Executive Director's Recommendation

PROJECT U.S. Park Police Stables Replacement and Site Improvements National Mall Independence Avenue, SW, South of JFK Hockey Fields Washington, DC	NCPC FILE NUMBER 8170
SUBMITTED BY United States Department of the Interior National Park Service	NCPC MAP FILE NUMBER 1.43(38.00)45116
REVIEW AUTHORITY Federal Projects in the District per 40 U.S.C. § 8722(b)(1) and (d)	APPLICANT'S REQUEST Approval of preliminary and final site and building development plans
	PROPOSED ACTION Approve preliminary and final site and building development plans
	ACTION ITEM TYPE Consent Calendar

U.S. Park Police Stables Replacement and Site Improvements

Approval of Preliminary and Final Site and Building
Development Plans

Proposed Plan – Surface Materials

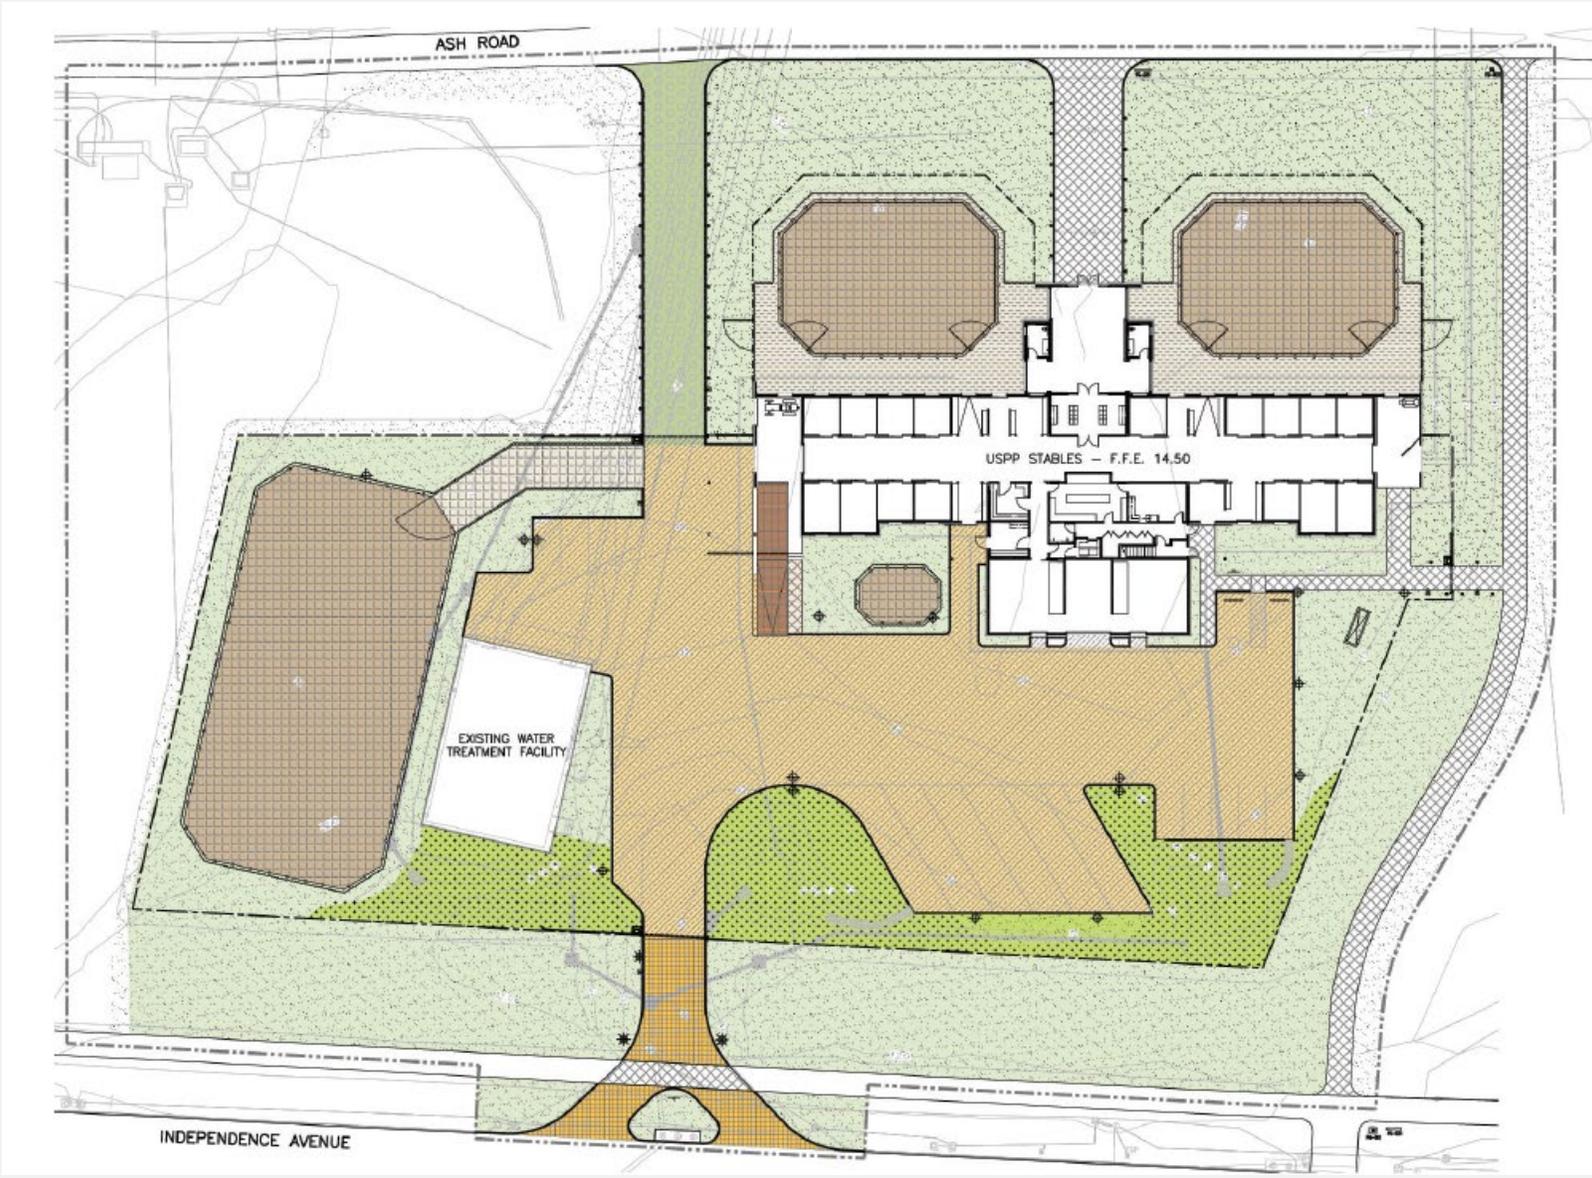
As proposed, the open space between the front of the public paddocks and Ash Road will consist of regular turfgrass with new and preserved trees. Given the anticipated popularity of the public paddocks, staff suggests the **Commission recommends the applicant consider using reinforced turfgrass between the public paddocks and Ash Road instead of regular turfgrass to endure high volumes of foot traffic.**

Recommends the applicant consider using reinforced turfgrass between the public paddocks and Ash Road instead of regular turfgrass to endure high volumes of foot traffic.
